Re: **Sheffield Gardens, a 261 unit Apt. complex on 17K**

Conservation Advisory Council Comments on the Sheffield Gardens Proposed Project

Reference: Sheffield Gardens

Comment 12.# - Planning Board comments dated 5/9/2025

Figure 4C-4. Warrant 3, Peak Hour (70% Factor)
(COMMUNITY LESS THAN 10,000 POPULATION OR ABOVE 40 MPH ON MAJOR STREET)

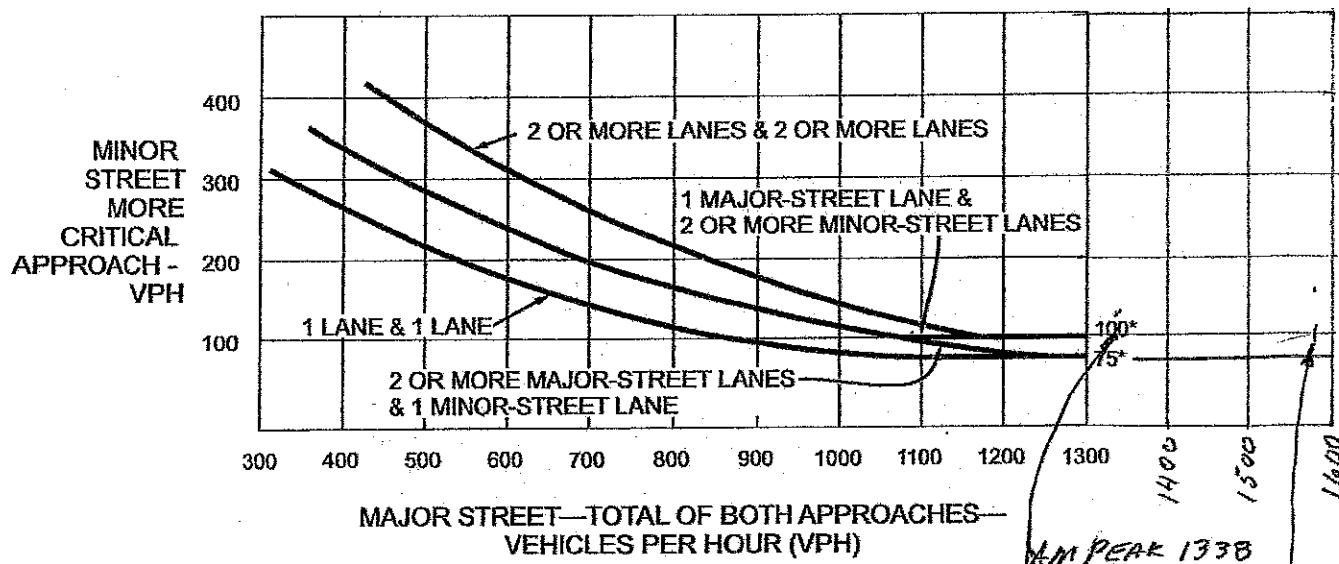
Since the speed limit on 17K exceeds 40 mph, Figure 4C-4 may be used to evaluate the criteria for the warrant.

The attached sheets present my analysis of the Warrant. Please note that the AM peak hour, PM peak hour, and Saturday peak hour all fall above the applicable curve (75 vehicles per hour) on Figure 4C-4. In fact, the Major Street vehicles per hour are “off the chart”.
